Vibro Champ Reverb MkII

Circuit Diagram	bja 04-05-2018
SE-Guit Amp w Reverb & Tremolo	
Steven Puddnhaid Husting	
Rev 1.01	Sheet 1 of 1

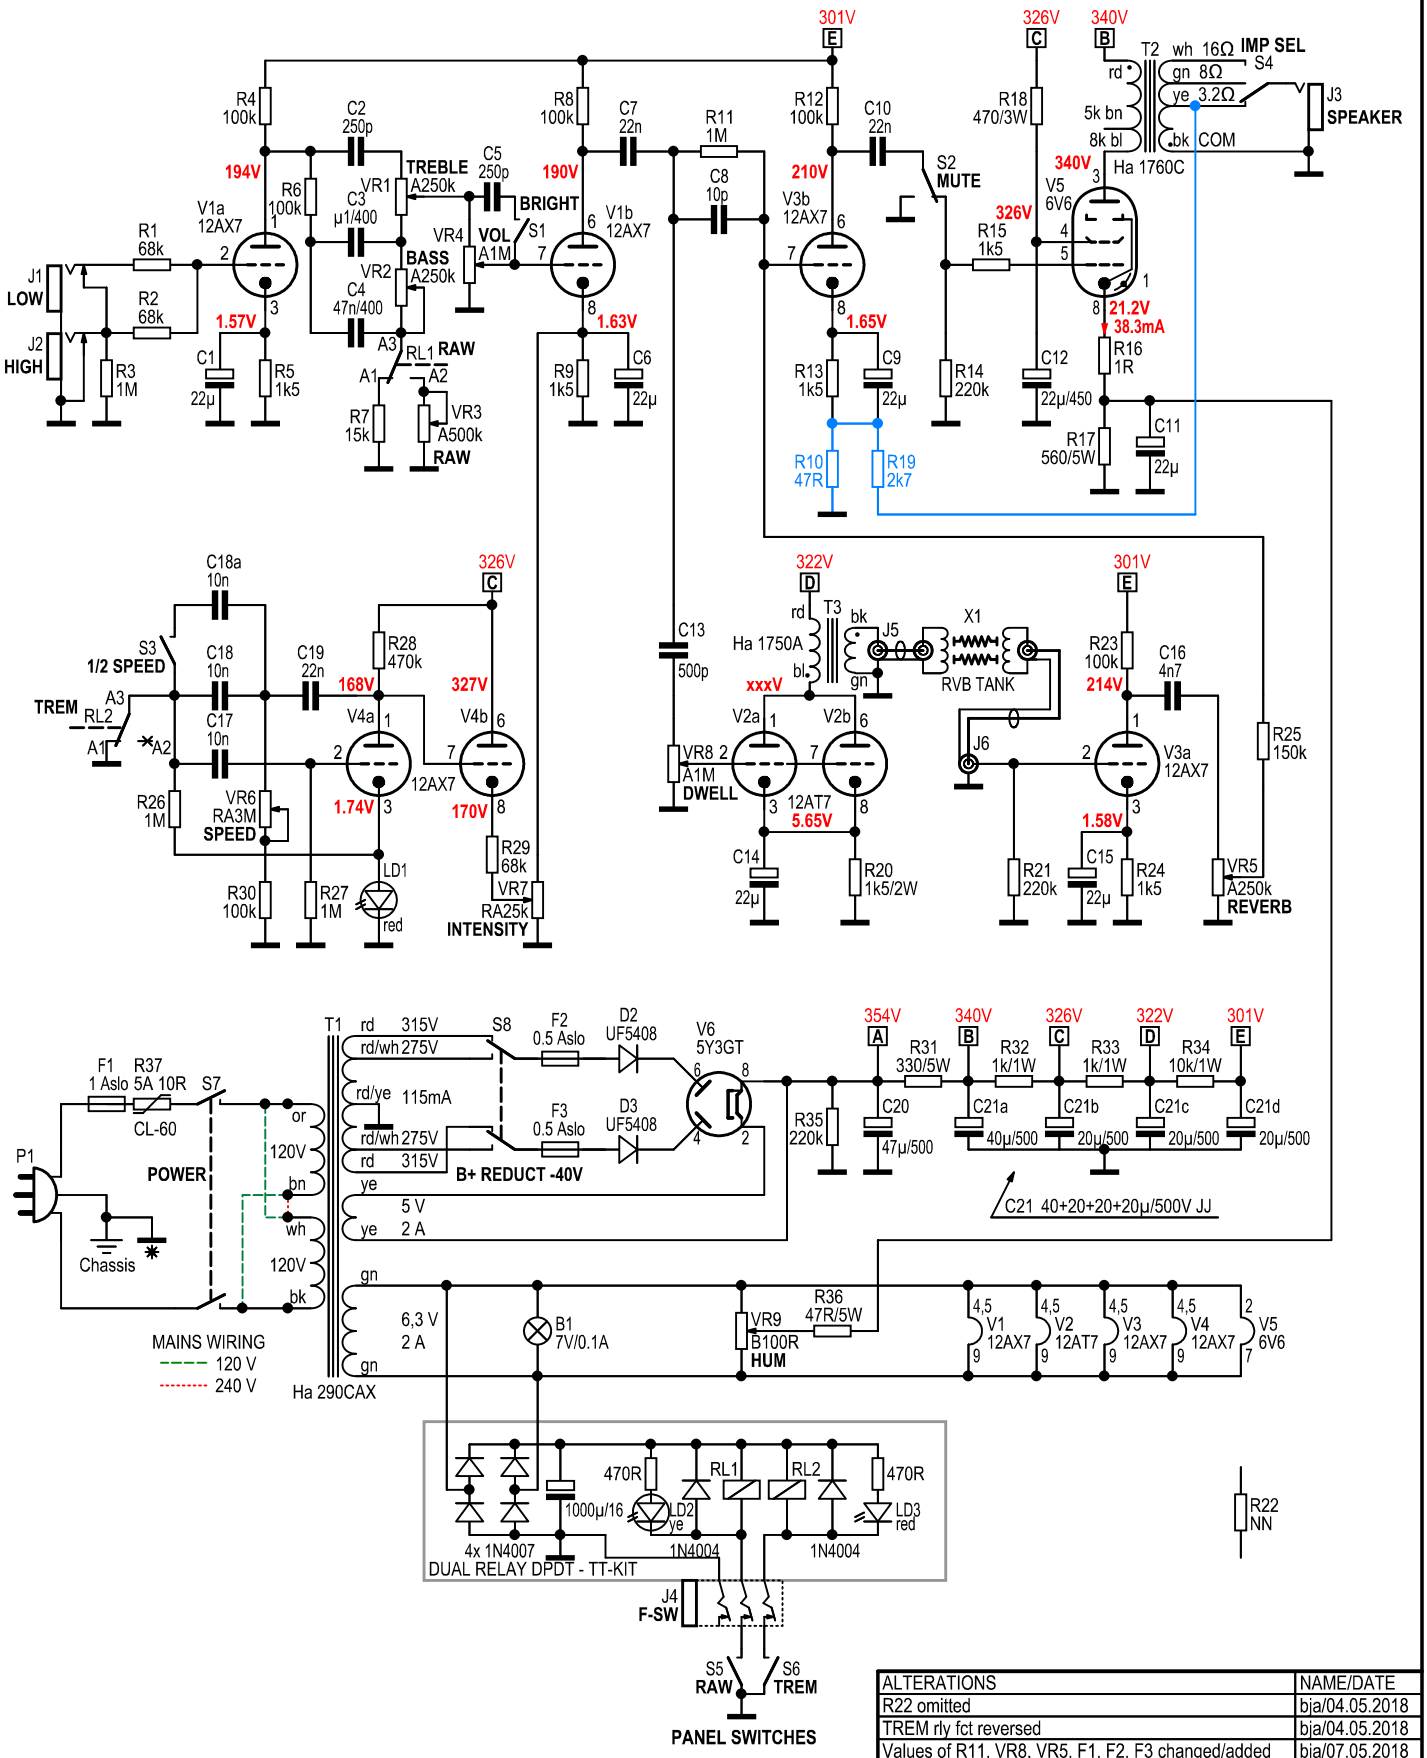
C8: optional switching, removing reduces highs
R11: larger values (1M...3M) inreases reverb
C12: shunts ripple to ground
C16: originally 3n3
R25: reduced to increase reverb (org. 470k)
VR7: replacement RA50k || 47k
T1: alternate wiring for 120 V or 240 V AC input
J4: Foot switch uses dual relay DPDT kit from Tube Town

X1: Reverb Tank Type?

ALTERATIONS	NAME/DATE
R22 omitted	bja/04.05.2018
TREM rly fct reversed	bja/04.05.2018
Values of R11, VR8, VR5, F1, F2, F3 changed/added	bja/07.05.2018
NFB as in the Champ (as a draft!) added: R10 shifted and R19 added (blue details)	bja/07.05.2018
